Meeting Minutes Transmittal

IHLW and ILAW Tri-Party Agreement Definitions of Critical Systems
and 80% Design MediaEcology Offices
1314 West Fourth Avenue
Kennewick, Washington
February 18, 2003
3:00 p.m. – 4:30 p.m.RECEIVED
AUG 07 2003
EDMC

Purpose: IHLW and ILAW Tri-Party Agreement Definitions of Critical Systems and 80% Design Media

**PROJECT W-464 AND W-520 RECOVERY PLAN DEFINITIONS OF CRITICAL
SYSTEMS AND 80% DESIGN MEDIA**

Tube Assemblies in the Canister Storage Building

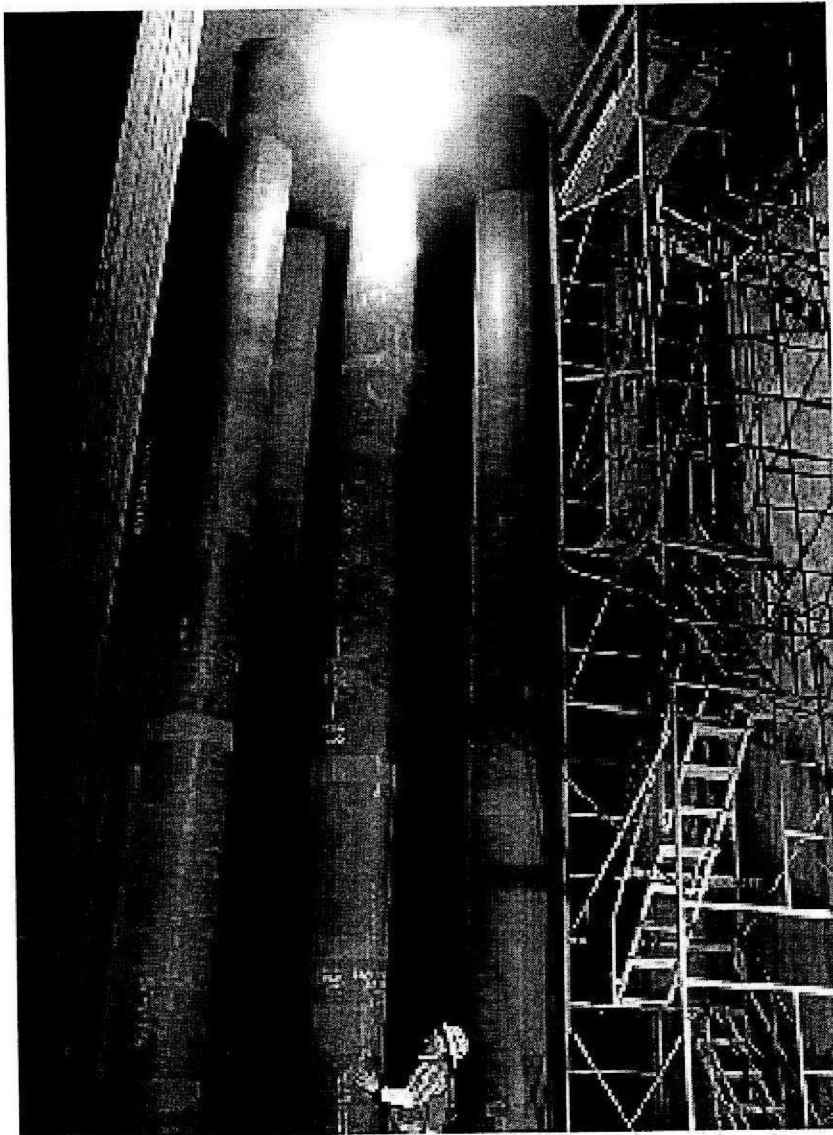
Kris Colosi -Gave an overall description of the CSB using the cut-away drawing from the last page of the presentation. Referring to page 12 of the presentation, Ms. Colosi stated construction of non-critical systems must begin 5-2004 to support a construction completion date of 9-2006. Construction of critical systems must begin 4-2005, three months earlier than the two years allotted for a final status permit. In addition, procurement of critical systems must begin prior to receipt of a final status permit.

Rick McNulty – Stated the permit application will be submitted as a container storage unit and asked if the tube system should still be identified as a critical system since the canister provides primary containment and the tube is secondary containment. Mr. McNulty suggested the canister would be the critical system and no longer the storage tube system. The canister is included in the WTP permit. Mr. Skurla stated this topic would require internal discussion.

Steve Skurla – Inquired about canister ventilation. Ms. Colosi explained the natural convection (passive ventilation) system cools the sealed tubes with air passing the outer surface of the tube and HEPA filters would not be used for vault cooling but are used for the operating deck system.
